Year 3 Monitoring Report
FINAL
Greenbrier Stream Mitigation Project

NCDEQ Contract No. 7616
DMS ID No. 100086
USACE Action ID No. SAW-2018-01755
NCDWR ID: 20181272
Yadkin River Basin
HUC 03040101

**RE: Response to Draft MY3 Monitoring Report Comments dated December 2, 2022
Greenbrier Stream Mitigation Site
Yadkin River Basin – CU# 03040101 - Yadkin County, North Carolina
NCDMS Project # 100086, Contract # 7616**

FIGURE 2

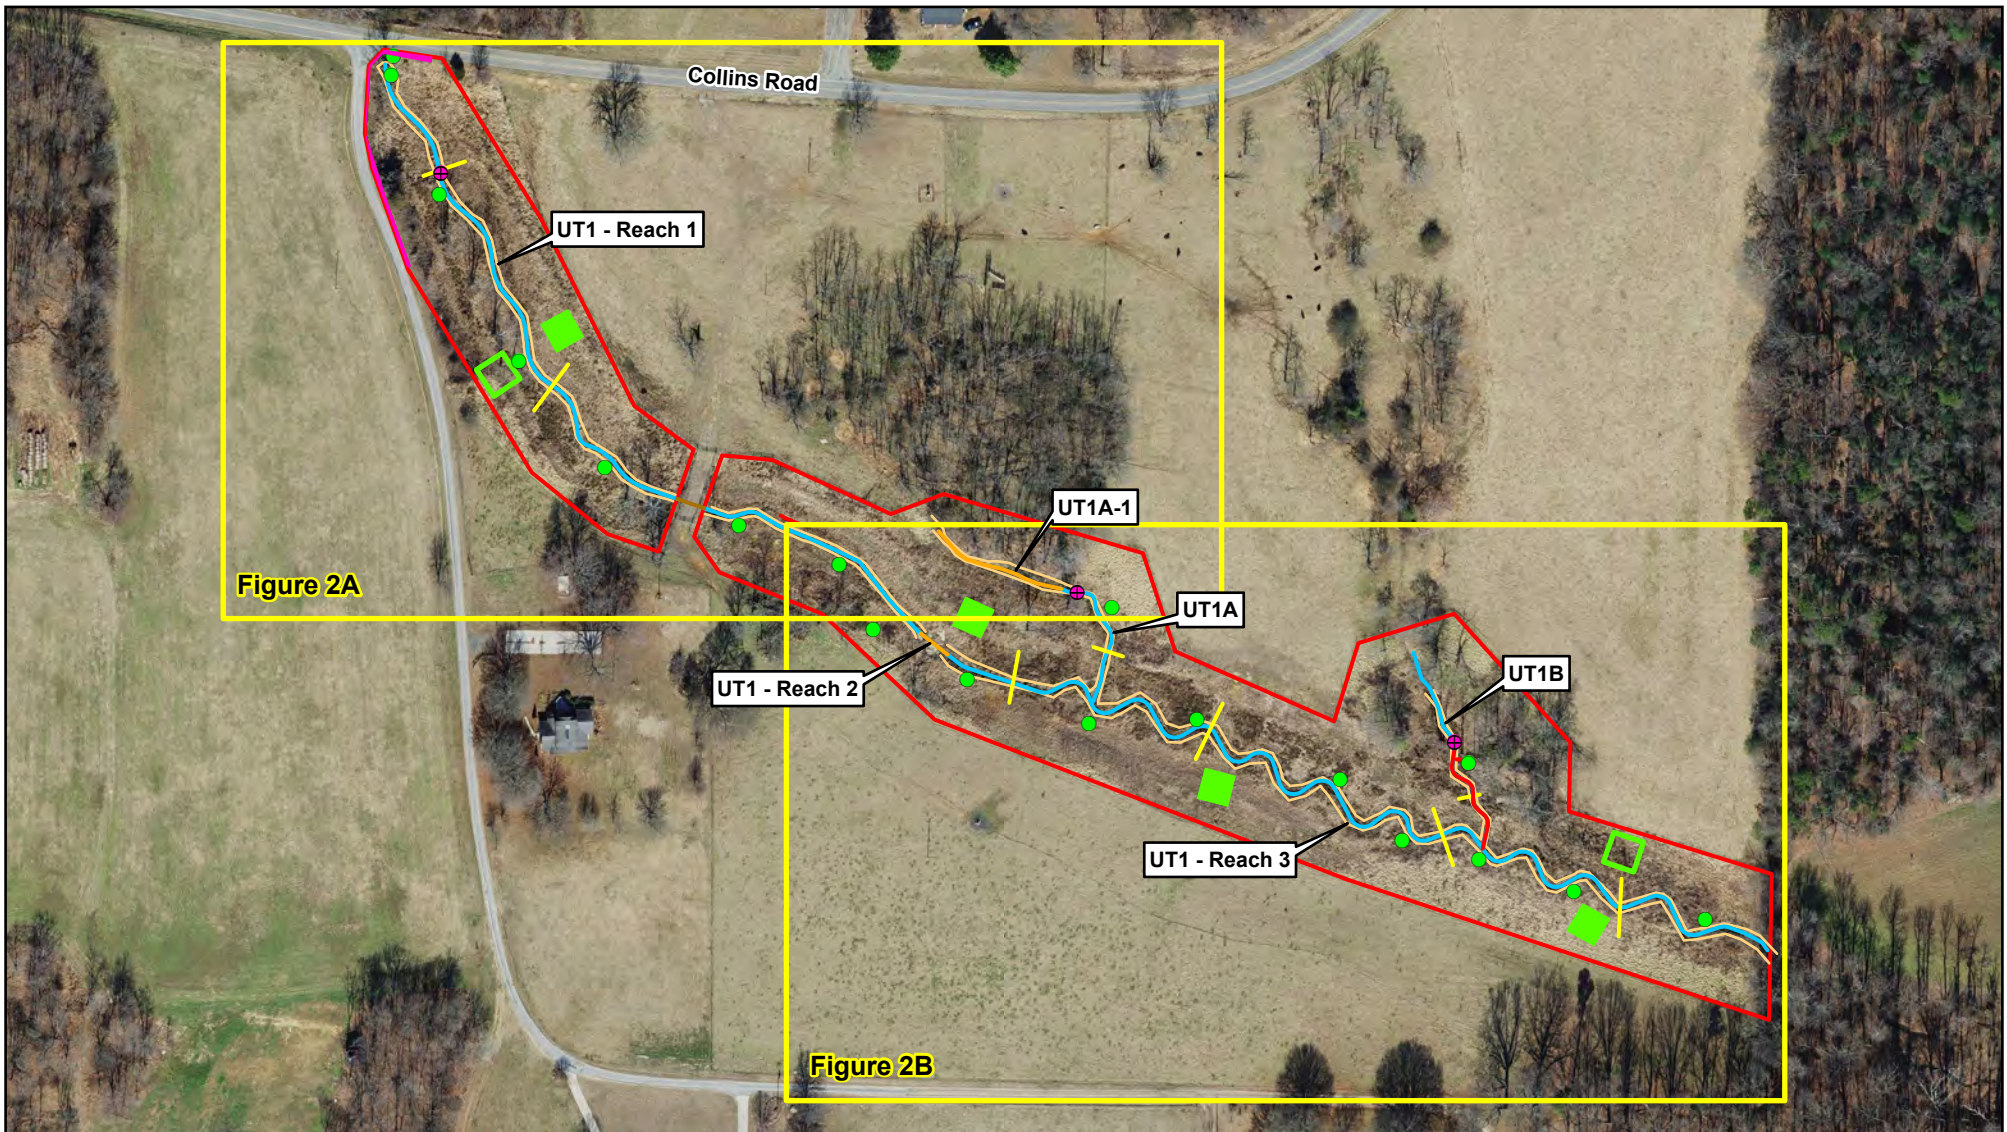
- **CCPV Maps & Table 5. Vegetation Condition Assessment Table** - *The project encroachment identified on the site on 11/8/22 should be clearly shown on the CCPV maps and reported in the Table 5 vegetation condition assessment table.*
 - **Easement encroachment area has been added to the CCPV and Table 5 has been updated accordingly.**

- **CCPV Maps** – *In the map legend, please update Streams – Enhancement to Streams – Enhancement II. Two (2) small, vegetated overbank side channels were noted in the 11/8/2022 IRT credit release site visit meeting notes. Please show these areas on the CCPV map sheets for reference and briefly discuss them in the report text. EPR committed to taking additional photos of these areas in future project monitoring reports.*
 - **The CCPV maps have been updated to show the Enhancement streams as Enhancement II. The two small overbank side channels have also been added to the CCPV as CPA-1 and CPA-3. A discussion of how they will be monitored in future years has been added to the report in Section 2.1.3.**

GREENBRIER STREAM RESTORATION SITE
 CURRENT CONDITION PLAN VIEW: OVERVIEW MAP
 MY2: 2021

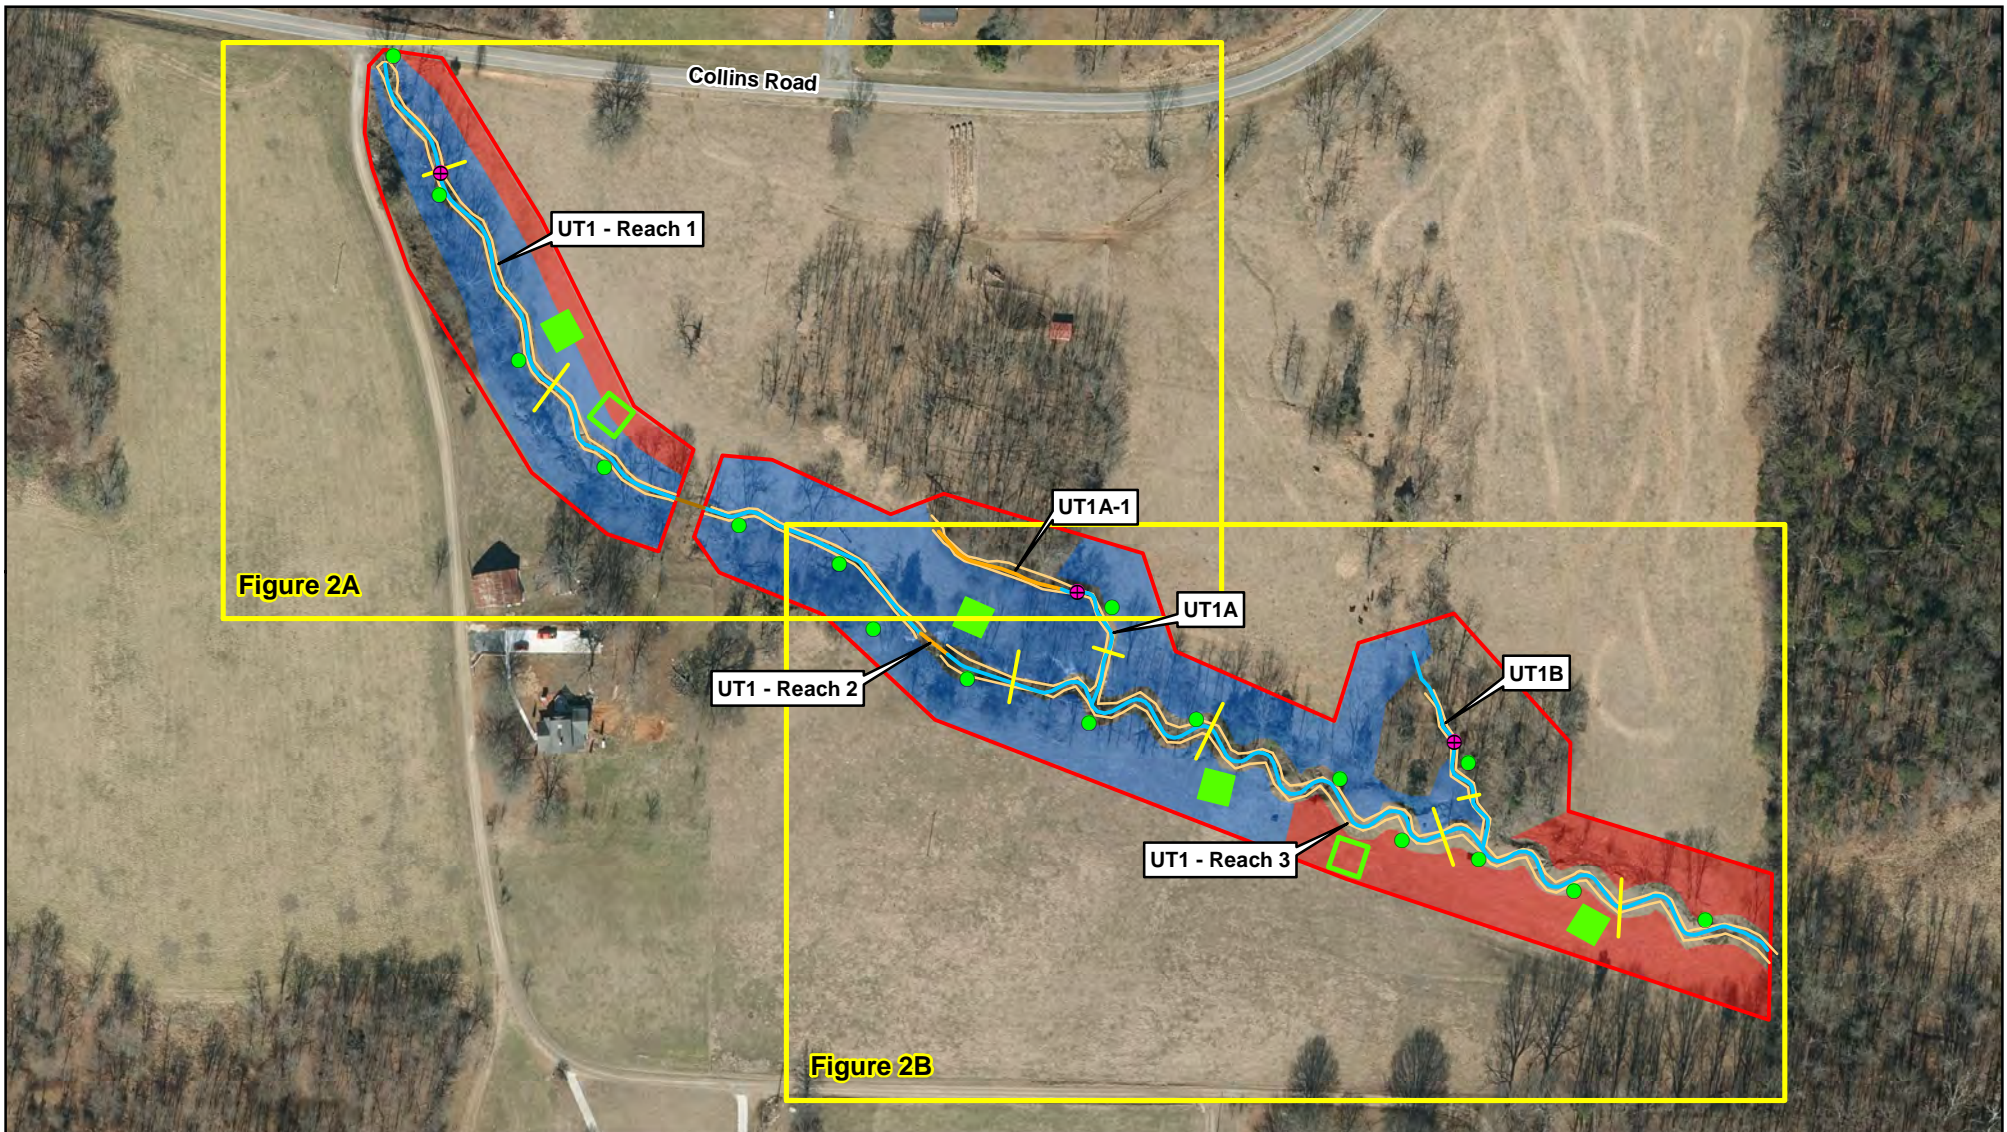
- **Section 2.2.1 Vegetation Monitoring Data** - *This section indicates that the MY2 (2021) supplemental planting area is shown on the CCPV maps. This is incorrect. DMS recommends adding the 2021 supplemental planting map to Appendix B along with the 2021 supplemental planting list. In addition, the report text regarding the 2021 supplemental planting does not appear to be consistent with the Greenbrier 2021 Supplemental Planting Species List provided in Appendix B. The planting list appears to have discrepancies as well. Please QA/QC the report text and planting list in Appendix B to confirm they are correct and consistent*
 - **Appendix B has been updated to include the correct supplemental planting list. Appendix B now includes Greenbrier MY2 CCPV which shows areas that were supplementally planted in 2021.**

XS3 - UT1 Reach 3

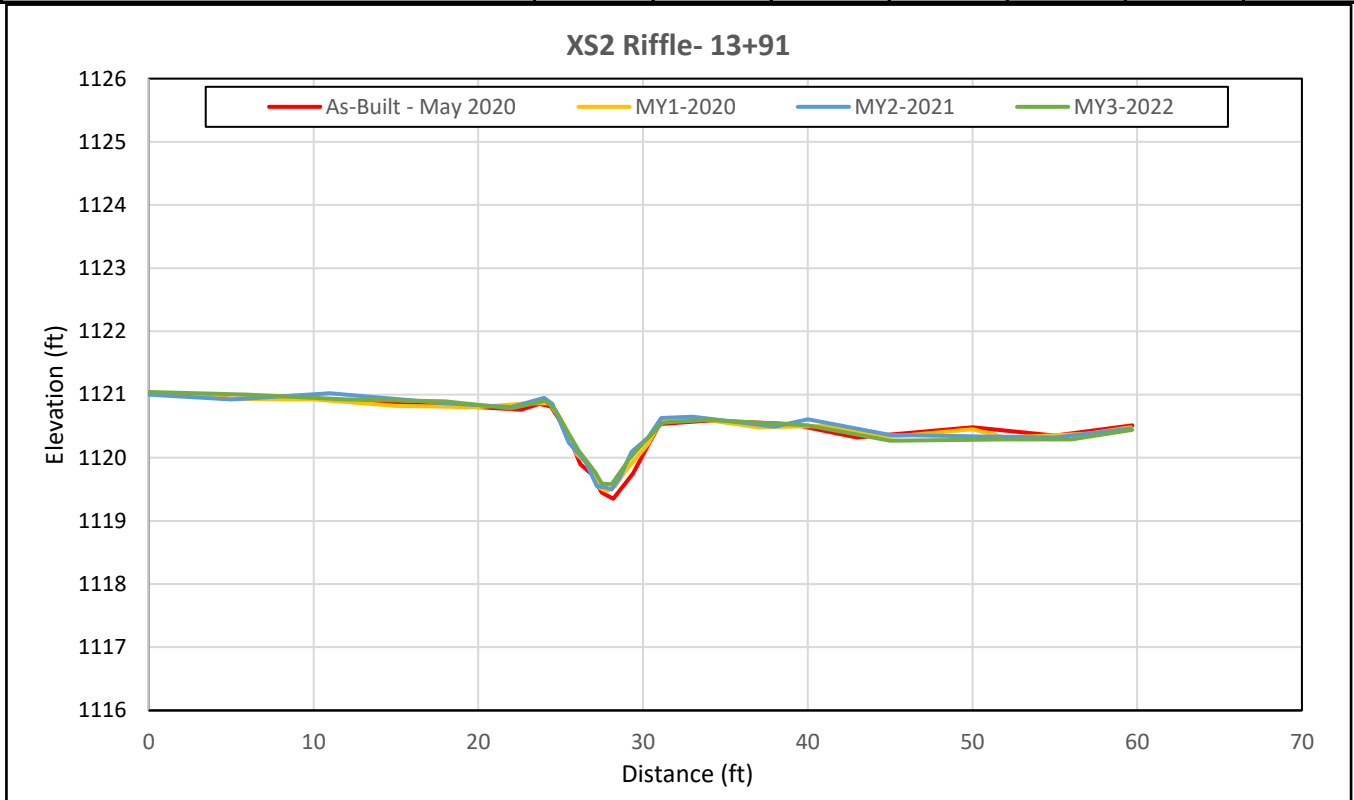
- *The identified LTB in a few of the cross sections seems slightly off (ex. cross section 3). Please review the data and confirm its accuracy.*
 - **After reviewing cross sections, XS-5 LTB was changed to a lower elevation on the opposite bank. XS-5 now has a bankfull area that is closer to As-built conditions and the bank height ratio is near 1.0. All other cross sections reviewed had reasonable LTB calls that coincide with previous monitoring years' stationing and elevation.**

XS8 Riffle- 11+71

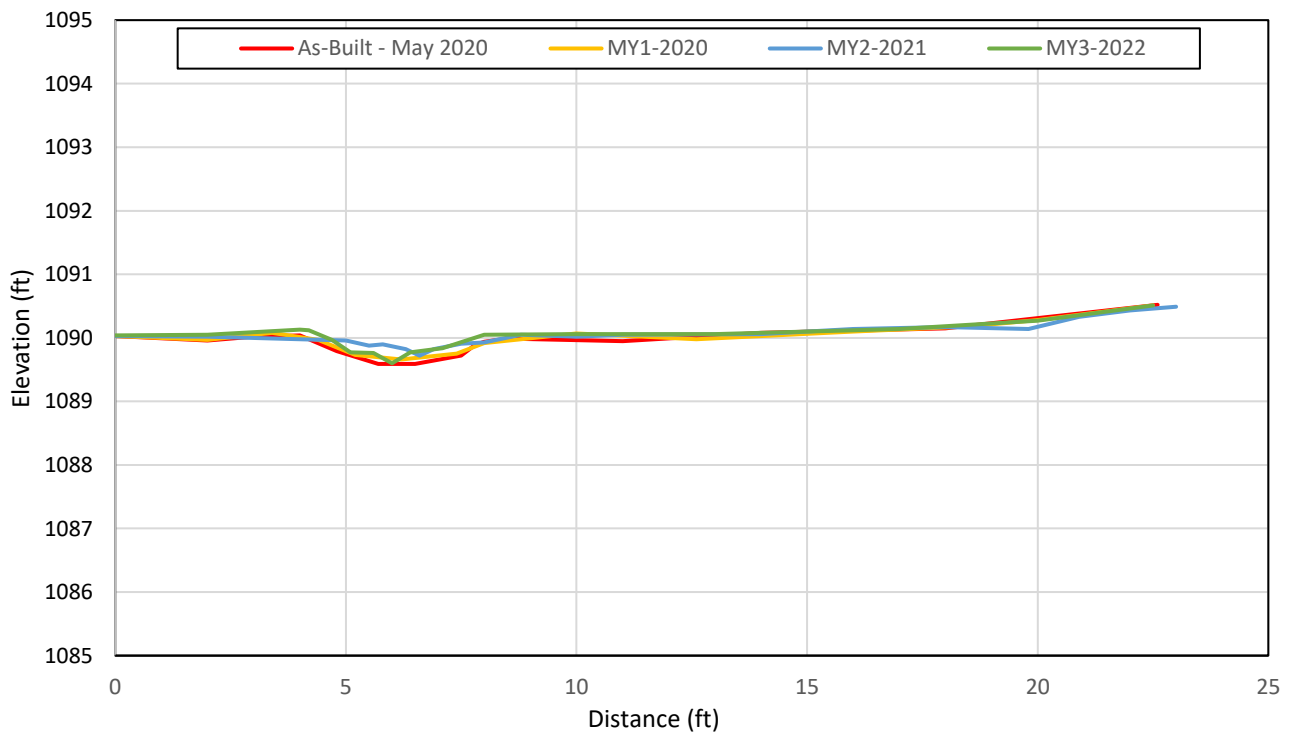
The IRT noted that cross-section 8 on UT1b appears to be aggrading. The IRT requested that this cross section be discussed, and all cross sections be reviewed and discussed in detail in the MY3(2022) report.

- **Cross section 8 on UT1B has experienced some growth of channel vegetation in past monitoring years that has resulted in a decrease in bankfull area from year to year. In MY3, it was noted that this cross section is now almost entirely shaded and vegetation should not be as much of an issue in future monitoring years. This is addressed in the Final Report.**

GBSG2

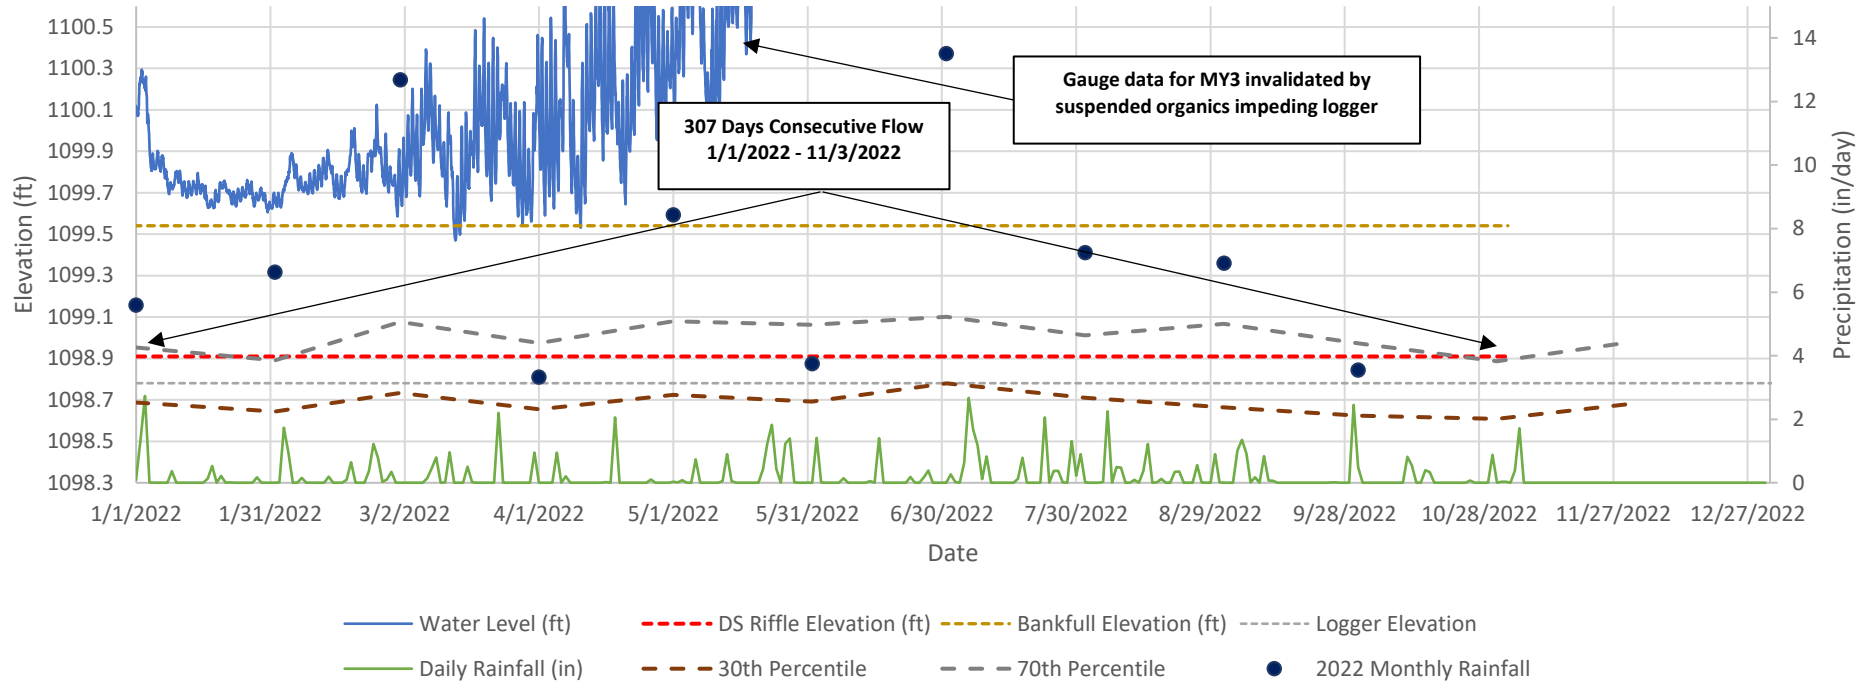
- *The number of days of consecutive flow indicated in the tables beneath the graphs for gauges 2 and 3 do not appear to be accurate. Please specify the 307 and 54 days of consecutive flow indicated on the GBSG2 and GBSG3 graphs respectively; the water level presented in the first is not sufficient to sum to 307 and the level appears to fall below the downstream thalweg elevation for many of the 54 days in the latter. Please review and resubmit these electronic gauge files and update the MY3 report as necessary.*

- **All hydrographs have been updated to show number of consecutive flow days and the specific dates. Consecutive flow days for SG1 and SG2 have been verified and are accurate. Water level readings for SG2 are likely being inflated by fine organic sediments from the upstream riparian wetland, but EPR believes this channel demonstrates near perennial flow due to groundwater interaction. A game camera will be installed on SG2 to provide further evidence of flow during MY4.**
